SUBJECT: SALEM NUCLEAR GENERATING STATION, UNIT NO. 1 – SUMMARY OF
OCTOBER 27, 2017, CONFERENCE CALL WITH PSEG NUCLEAR LLC
RE: FALL 2017 STEAM GENERATOR INSPECTIONS (CAC NO. MG0215;
EPID L-2017-LRO-0028)

SALEM NUCLEAR GENERATING STATION, UNIT NO. 1
STEAM GENERATOR TUBE INSPECTION DISCUSSION POINTS
(DRAFT INFORMATION)

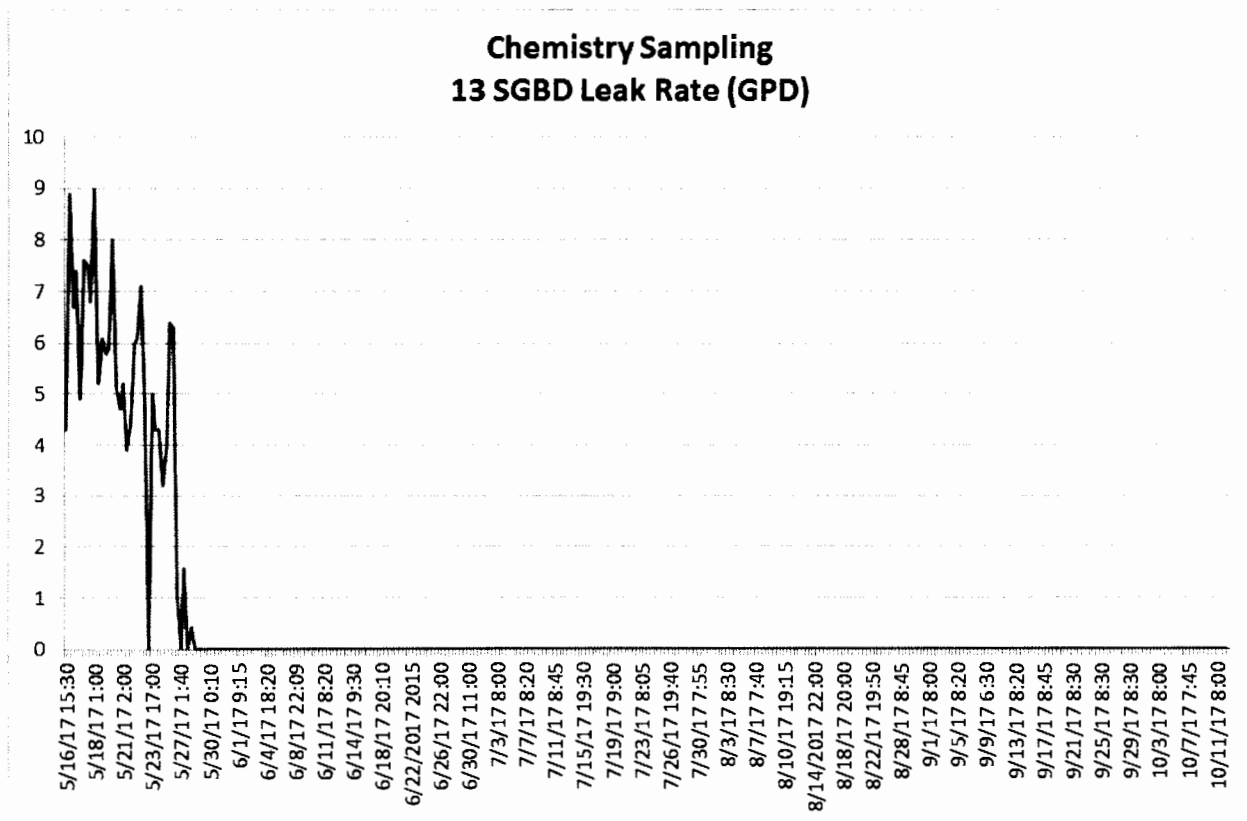
1. Discuss any trends in the amount of primary-to-secondary leakage observed during the recently completed cycle.

On Monday May 15, 2017 at approximately 1800, operators in the Salem-1 Control Room identified a rise in the primary-to-secondary leakage from radiation monitor indications. The small leak was identified in SG 13, and went below detection around May 28, 2017. Below is the chemistry grab sample results for the duration of the leak event, including up to the start of outage 1R25 (October 12, 2017). Subsequent to May 28, 2017, the leak remained below detection. Online radiation monitors provided similar trend.
